Access Compliance Report

Public Rights-of-Way

(Curb Ramps)

Intersection ID: 10029226	Main Street: JOHNSTON_RD	Cross Street: N/A	Location: S
ADA ID: DBE140A6C54F	Ramp Type: Perp	Initial Pass/Fail: Fail	Overall Compliance: No
			Severity Score: 21.25

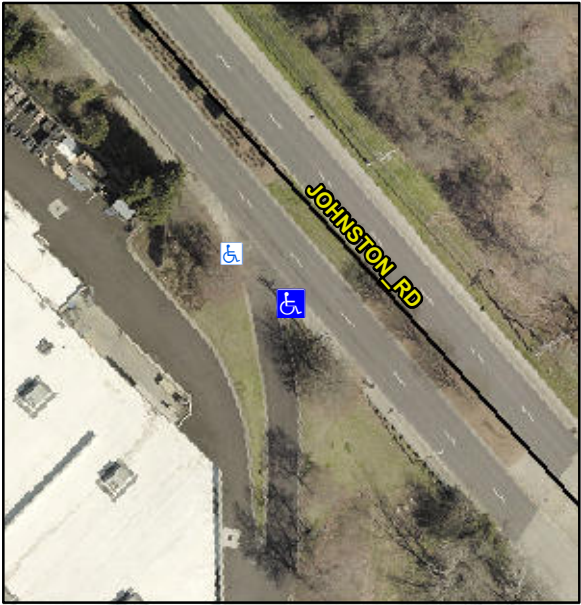
Codes/Mitigation Info/Possible Solution			Field Measurements/Component Compliance		
	Possible Solutions:		Compliance	Description	Data
	Remove & Replace Entire Ramp.		No	Ramp Length (in)	66.0
			No	Ramp Width (in)	46.0
			N/A	Flare Type LT	N/A
			N/A	Flare Slope LT (%)	N/A
			N/A	Flare Traversable LT?	N/A
			N/A	Landing Length (in)	N/A
			N/A	Landing Width (in)	N/A
			N/A	Landing Slope (%)	N/A
			N/A	Landing X Slope (%)	N/A
<p>Surveyor Notes:</p> <p>N/A</p> <p>PROW/ADA:</p> <p>Not Found, R304.5.1, R304.2.2</p>			N/A	Flare Type RT	N/A
			N/A	Flare Slope RT (%)	N/A
			N/A	Flare Traversable RT?	N/A
			N/A	DWS Provided?	N/A
			N/A	DWS Contrast?	N/A
			N/A	DWS Length (in)	N/A
			N/A	DWS Full Width?	N/A
			N/A	DWS Offset (in)	N/A
			N/A	Gutter Ponding?	N/A
			N/A	Gutter Lip Ht (in)	N/A
			No	Painted X Walk1?	N/A
				X Walk 1 Direction	To NW
			N/A	X Walk 1 Width (in)	N/A
				X Walk 1 Slope (%)	1.7
				X Walk 1 X Slope (%)	2.5

N/A	Ramp inside XWalk1?	N/A
			N/A	Road Slope (%)	N/A
			N/A	Road X Slope (%)	N/A
			N/A	Any Obstructions?	N/A
				Obstruction Type	
Total Cost:					
		\$ 1850.00			
			N/A		N/A
			Yes	Surface Condition? (G/P)	Good
